PROPOSED COMPREHENSIVE PLAN AMENDMENT ADDENDUM

ITEM: SSPA 2018-1-1MS

Date of Addendum: September 10, 2019

SITE-SPECIFIC PLAN AMENDMENT 2018-I-1MS STAFF REPORT ADDENDUM

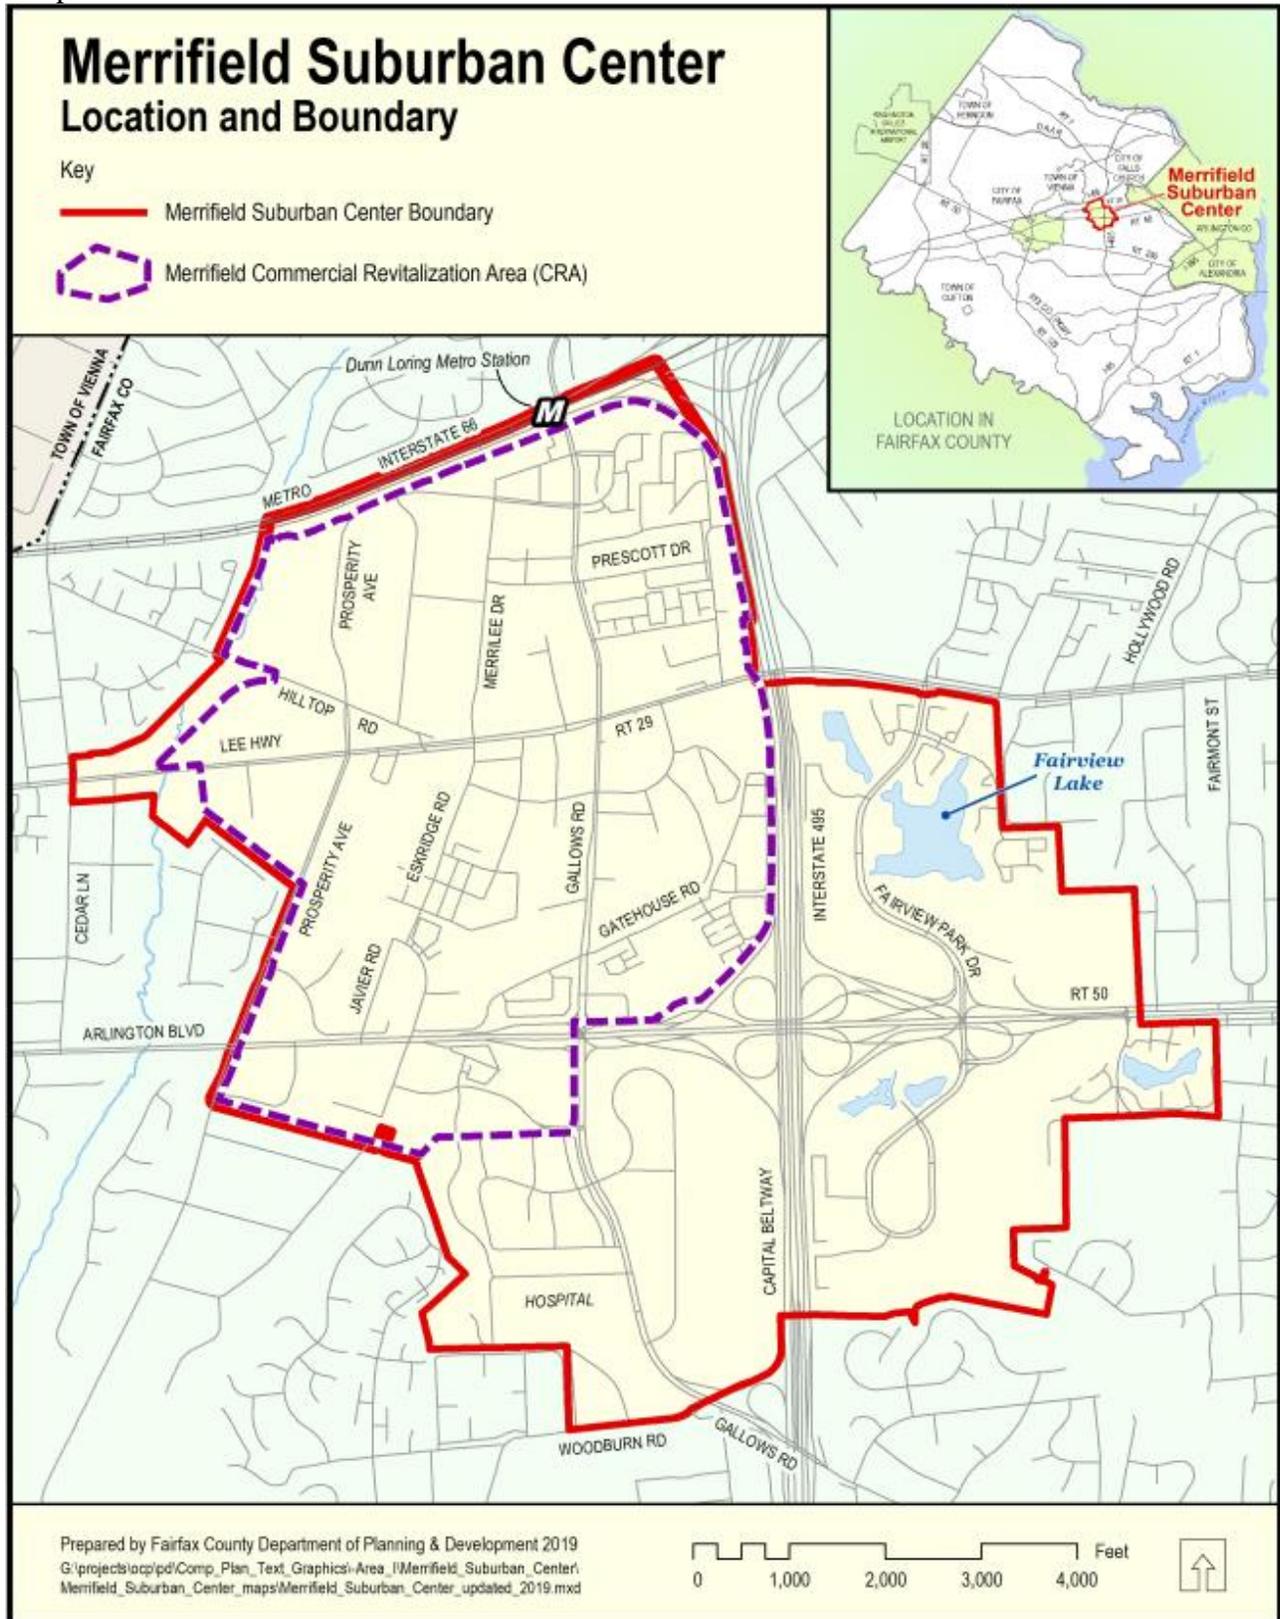
1286 **MODIFY FIGURE:** Fairfax County Comprehensive Plan, 2017 Edition, Area I, Merrifield
1287 Suburban Center, Area-wide Guidance, as amended through July 31, 2018, Figure 1, page 2 to
1288 move the word “HOSPITAL” further south to reflect the accurate location of Inova Fairfax
1289 Hospital.

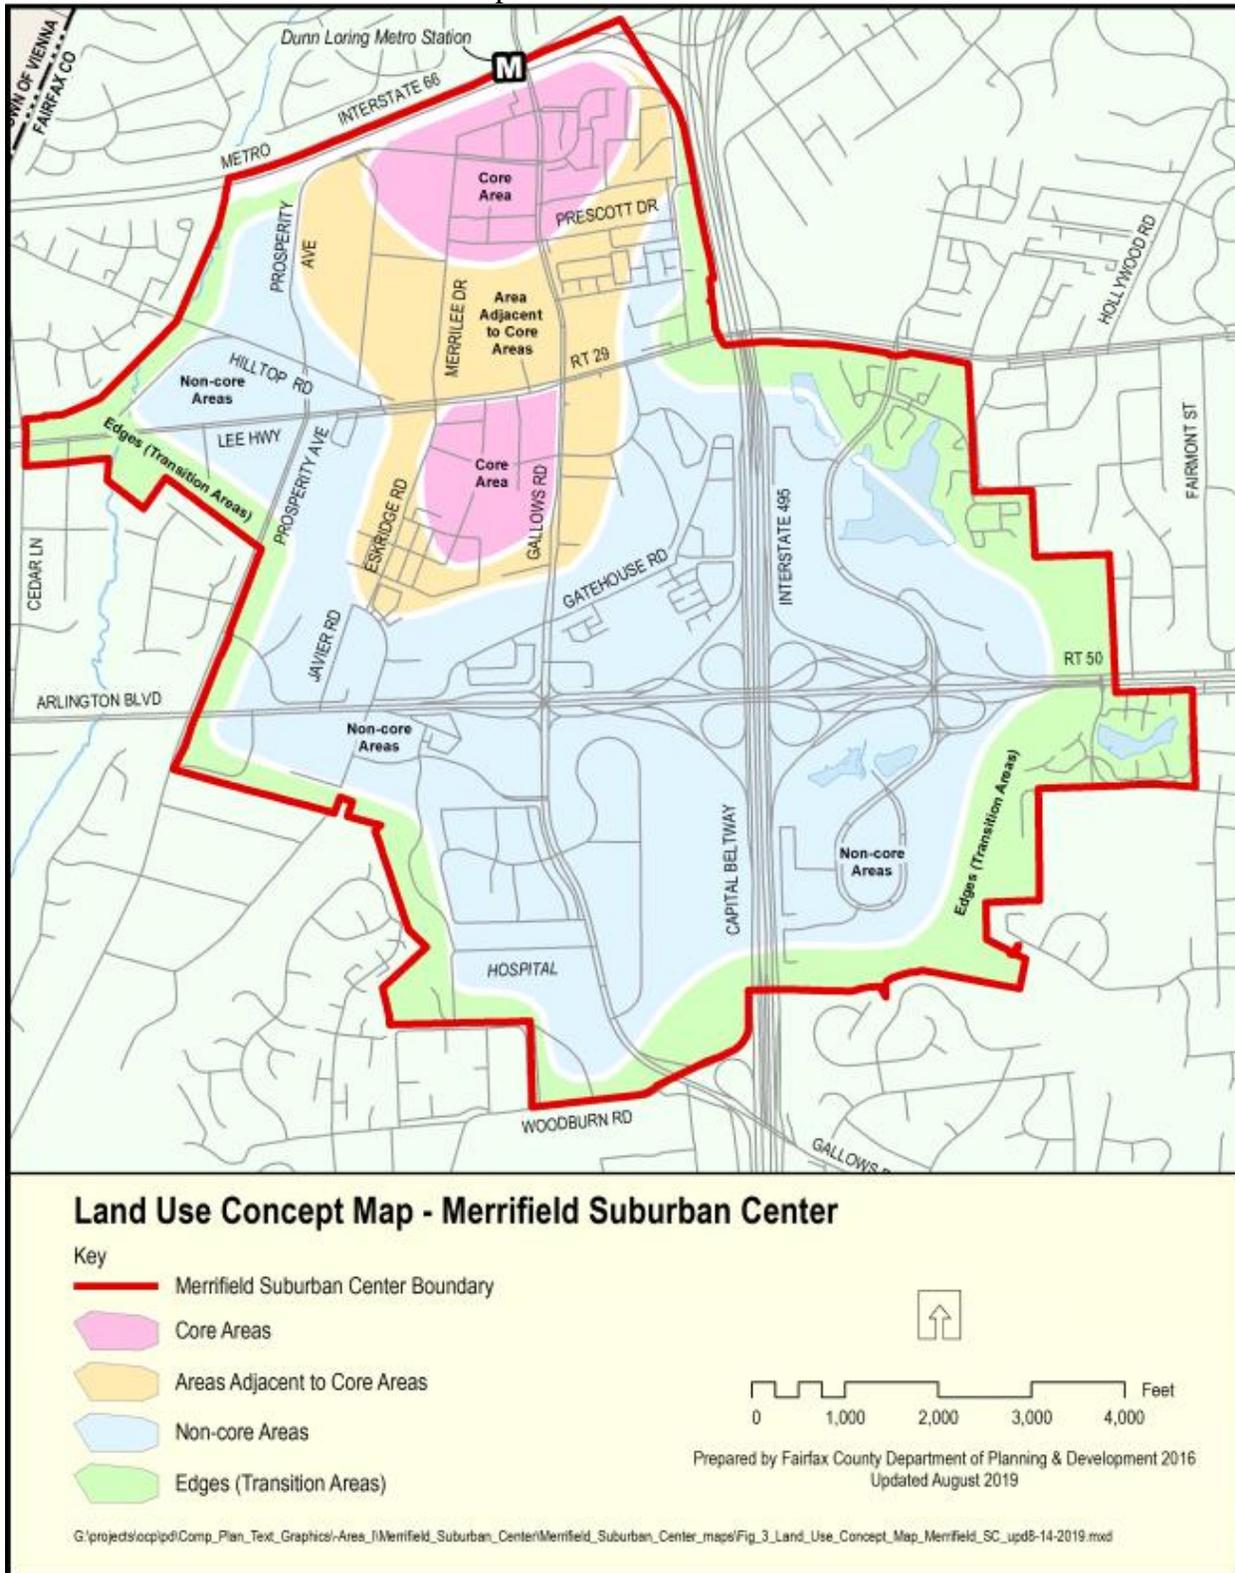
1291 **MODIFY FIGURE:** Fairfax County Comprehensive Plan, 2017 Edition, Area I, Merrifield
 1292 Suburban Center, Area-wide Guidance, as amended through July 31, 2018, Figure 1, page 2;
 1293 Figure 3, page 9; Figure 10, page 28 to move the word “HOSPITAL” further south to reflect the
 1294 accurate location of Inova Fairfax Hospital.

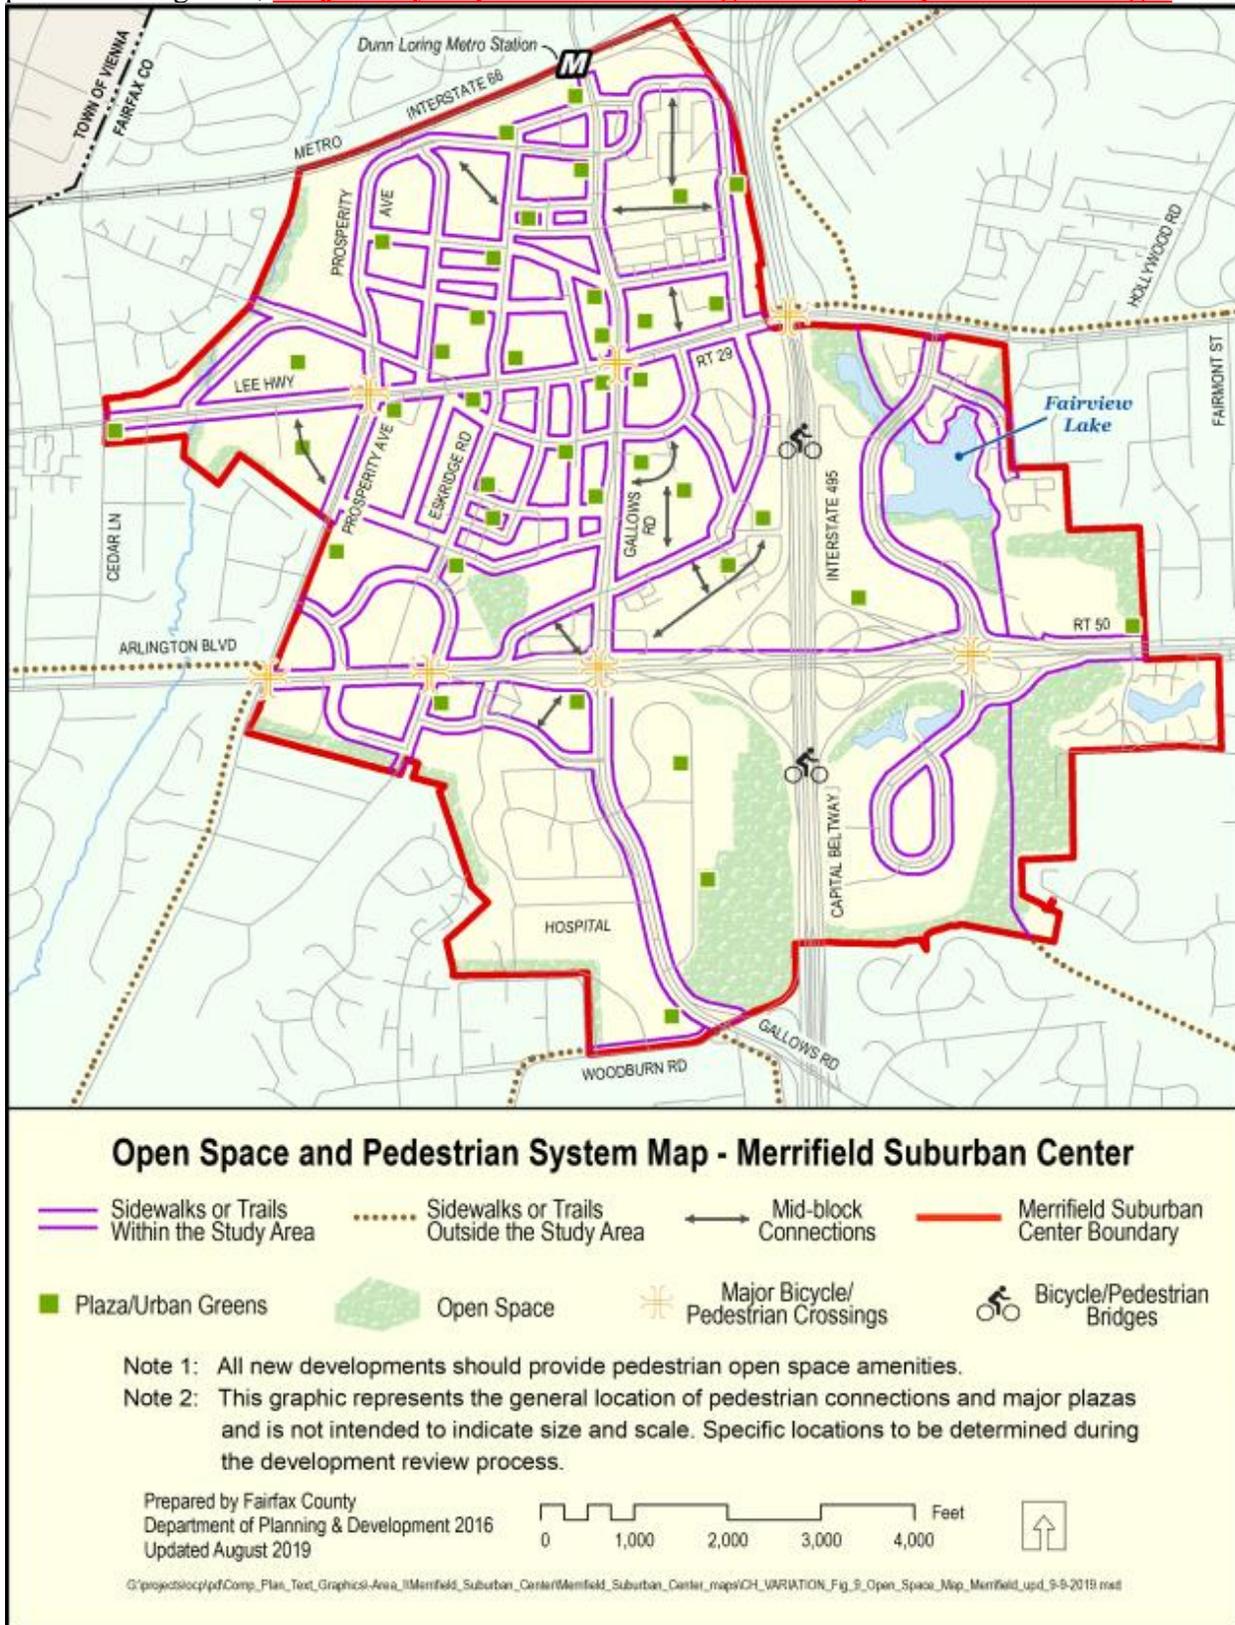
REPLACE FIGURE: Fairfax County Comprehensive Plan, 2017 Edition, Area I, Merrifield Suburban Center, Area-wide Guidance, as amended through July 31, 2018, Figure 9, page 24 to modify open space areas and add green squares in Land Unit K and Subunit II to reflect new plazas/urban greens, **- major bicycle/pedestrian crossings and bicycle/pedestrian bridges.**

Building Heights Map - Merrifield Suburban Center

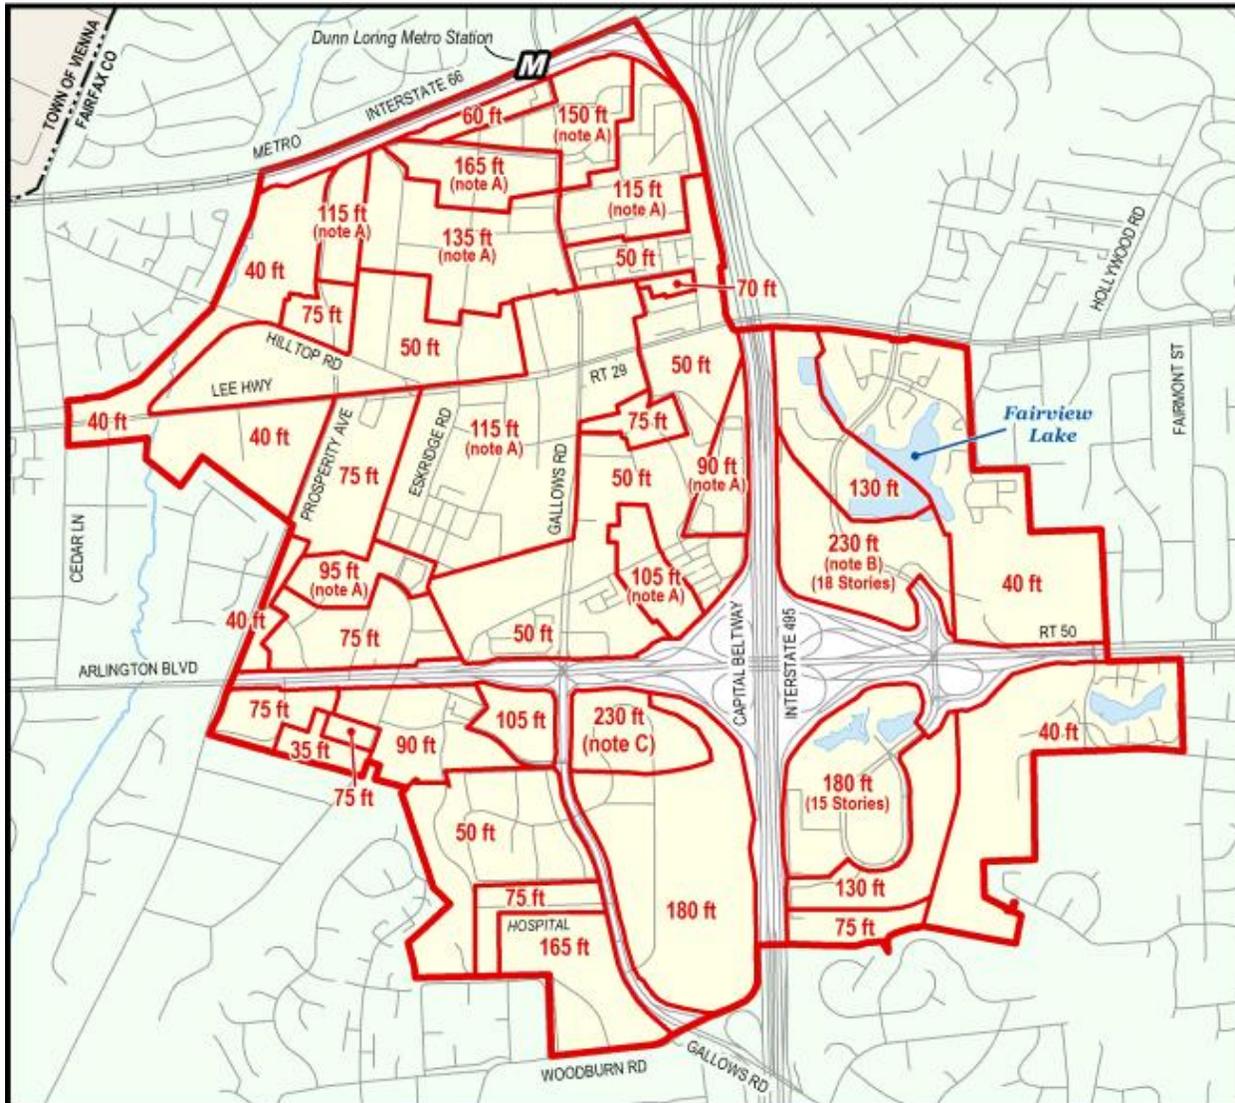
1302 **REPLACE FIGURE:** Fairfax County Comprehensive Plan, 2017 Edition, Area I, Merrifield
 1303 Suburban Center, Area-wide Guidance, as amended through July 31, 2018, Figure 8, Building
 1304 Heights Map to increase maximum building height shown on Land Unit K (in certain areas) from
 1305 180 feet to 230 feet, areas and to move the word “HOSPITAL” further south to reflect the
 1306 accurate location of Inova Fairfax Hospital.
 1307

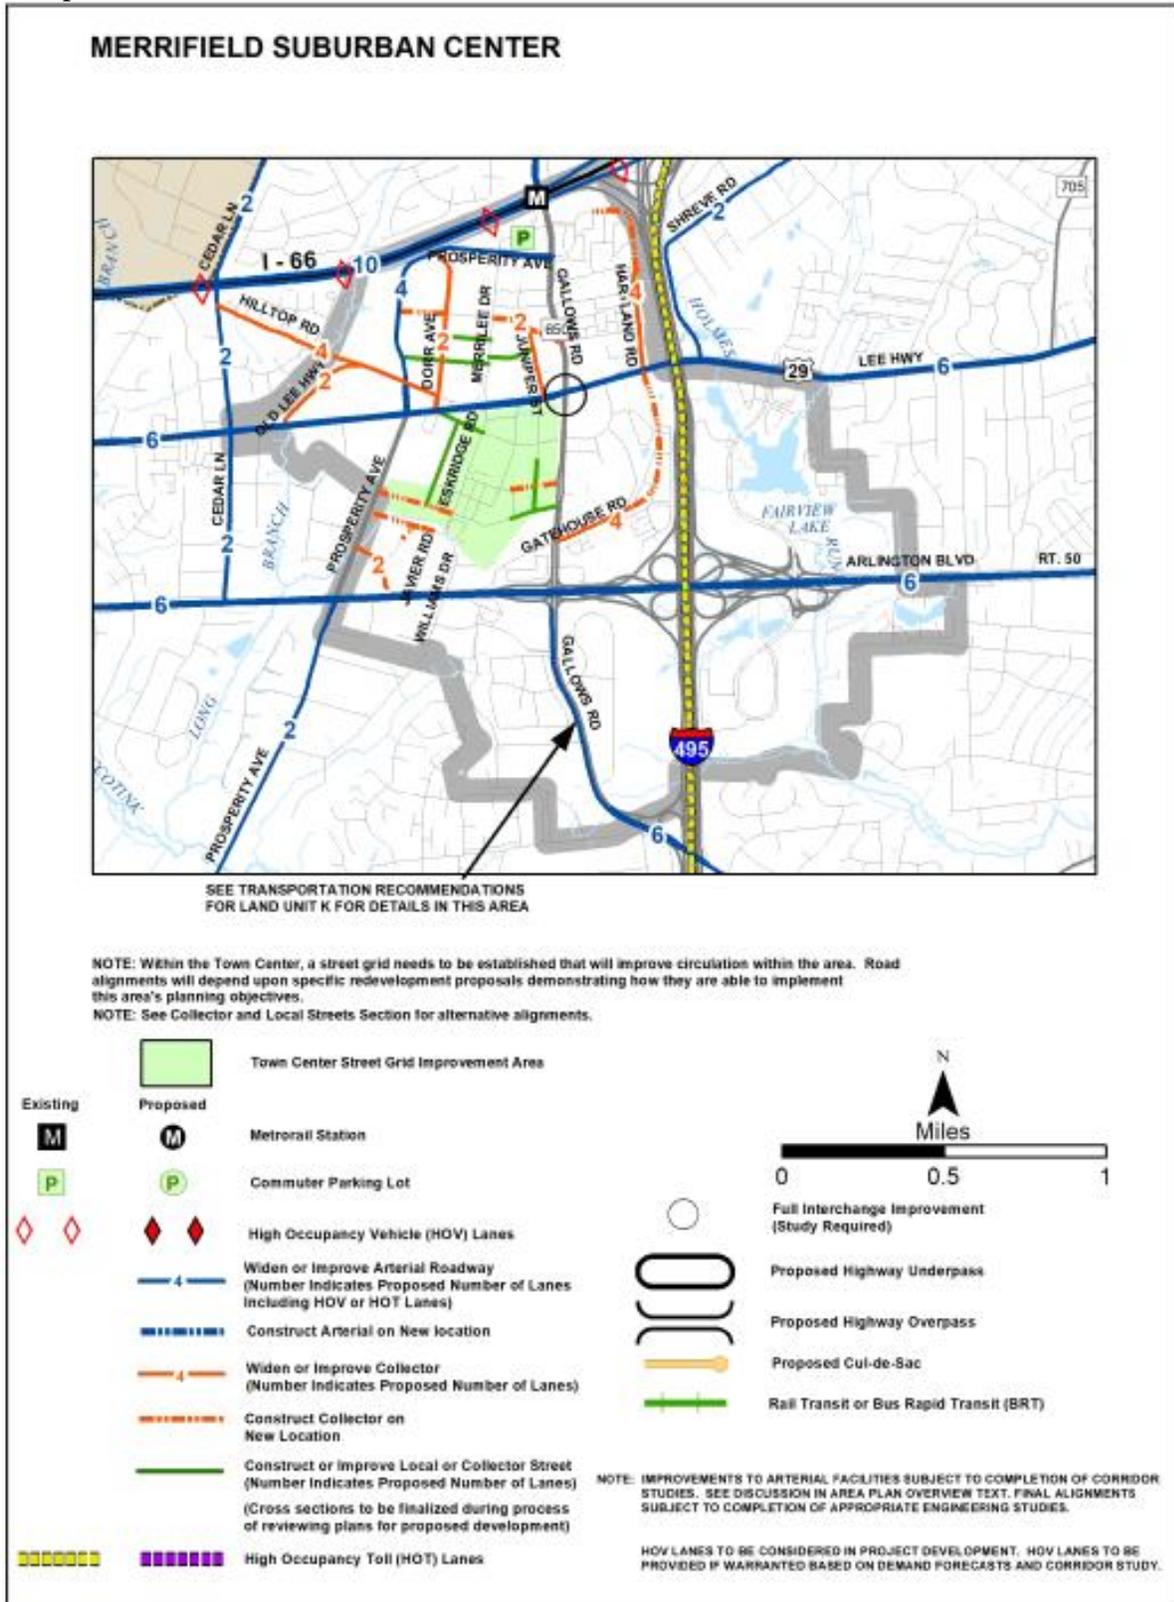
1309 **MODIFY FIGURE:** Fairfax County Comprehensive Plan, 2017 Edition, Area I, Merrifield
 1310 Suburban Center, Area-Wide Guidance, as amended through July 31, 2018, Figure 16,
 1311 Transportation Recommendations, page 43, to add a note that references additional
 1312 transportation recommendations in Land Unit K.
